NUMBER: 23-017-13

Rattle And/Or Buzz At The Right Rear Of Vehicle And/Or Fuel Door Will Not Open

2013 (PF) Dart

Fig. 1 Fuel Filler Hinge Pocket

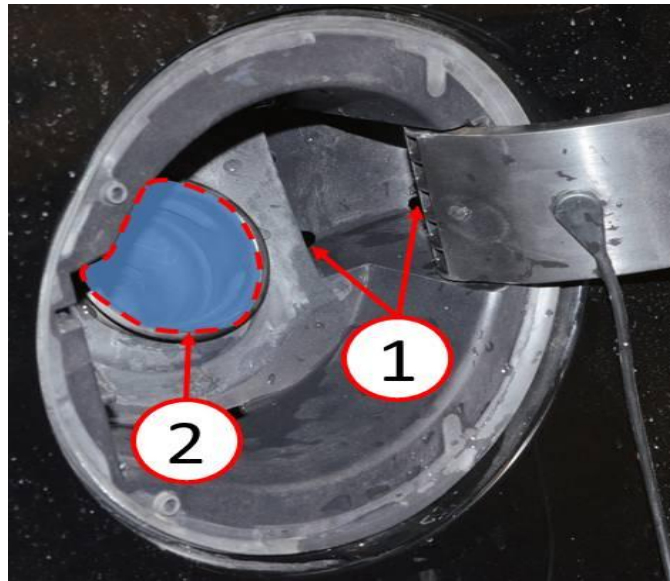
1. Is this vehicle in the Canadian Market or salt belt states which include Connecticut, Delaware, Illinois, Indiana, Iowa, Maine, Maryland, Massachusetts, Michigan, Minnesota, Missouri, New Hampshire, New York, Ohio, Pennsylvania, Rhode Island, Vermont, West Virginia and Wisconsin?
 - a. Yes >>> Proceed to [Step #2](#).
 - b. No >>> Proceed to [Step #6](#).
2. Open the fuel filler door and remove the fuel cap.
3. Cover the fuel filler neck with a rag or masking tape to prevent debris from entering the area.
4. Drill two 6mm (1/4") holes at the hinge pocket corner locations shown in ([Fig. 1](#)).

NOTE: : The housing and hinge pocket has a thickness of 3mm (1/8in), so a drill stop should be used at 5mm (3/16in) to ensure that nothing behind the housing is damaged from the drill bit.

- 1 - Hinge Pocket Corner Holes
- 2 - Protect Fuel Filler Neck

Fig. 2 Fuel Filler Door Inspection

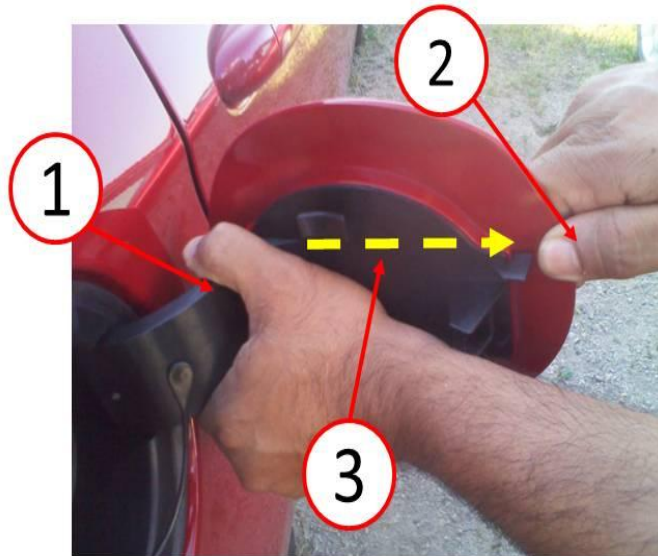
7. Inspect the fuel fill door and verify it is fully seated. With the fuel door open perform a light push pull around the fuel fill door. Grasp the fuel fill door hinge (1) with one hand and position the other at the rear edge of the door (2) lightly pulling out board (3) at the locations shown in (Fig. 2).

- 1 - Door Hinge
- 2 - Grasp the Fuel Door Here
- 3 - Pull Direction
